S E R V I C E N O T E

6035A Autoranging DC Power Supply

Prevent Spurious High Frequency Down Programmer FET Oscillations

Page 2 Service Note 6035A-04

FIGURE 1

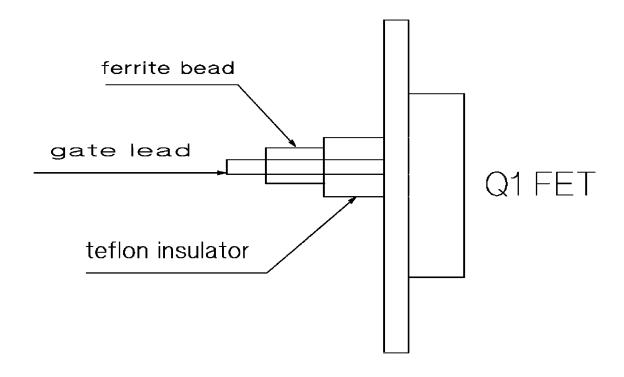
The downprogrammer power FET A5Q1 may exhibit spurious high frequency oscillations when the power supply output voltage is decreased at a slow slew rate.

Add magnetic shield bead, part number 9170-0894, to the gate lead of A5Q1 power FET. The magnetic bead should be inserted on the gate lead after inserting the teflon insulator. See figure 1.
